BAMx and CCSF Comments on CAISO 2012-2013 Transmission Study Plan

The Bay Area Municipal Transmission Group (BAMx)¹ and the City and County of San Francisco (CCSF) appreciate the opportunity to comment on the CAISO Draft 2012-2013 Transmission Study Plan (Study Plan). The comments and questions below address the presentations made by the CAISO during the February 28, 2012 Stakeholder meeting.

Figure 1: A Comparison of the 2020 Load Projection/ Energy Consumption (GWh) in PG&E and SCE Planning Areas under CEC's Preliminary and Revised Demand Forecasts in 2020

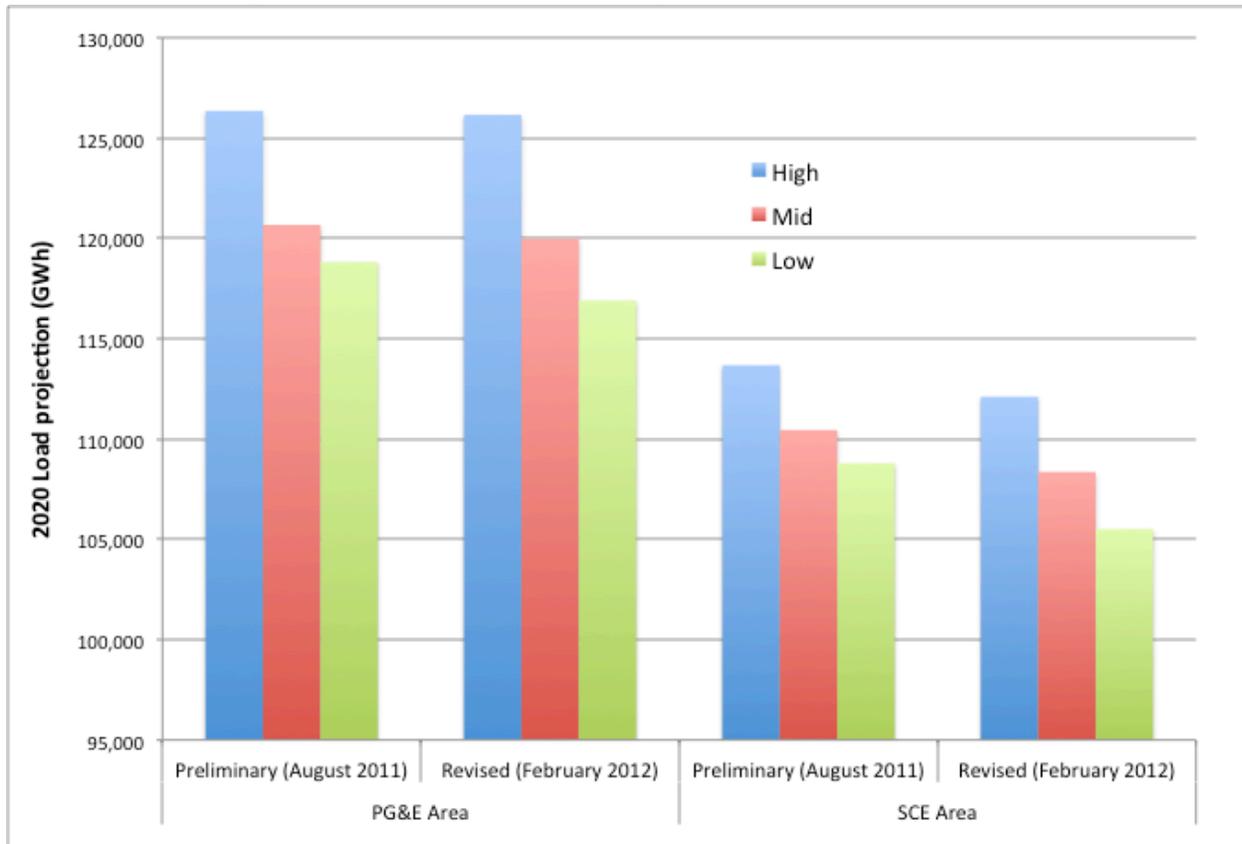
Figure 1 below shows that both for the PG&E and to a greater extent for the SCE planning areas, the 2020 load projections (GWh) are lower in the CEC’s revised forecast than in the preliminary forecast. This reduction in the revised load projections is primarily attributed to greater self-generation (including the effects of Self-Generation Incentive Program-SGIP, CSI, and other

programs) as well as higher Conservation/Efficiency Impacts amounts in the revised forecast than in the preliminary one.

BAMx and CCSF strongly urge the CAISO to consider utilizing the latest CEC demand forecast for the annual, five-year and ten-year Base Cases during the period of 2013-2022.
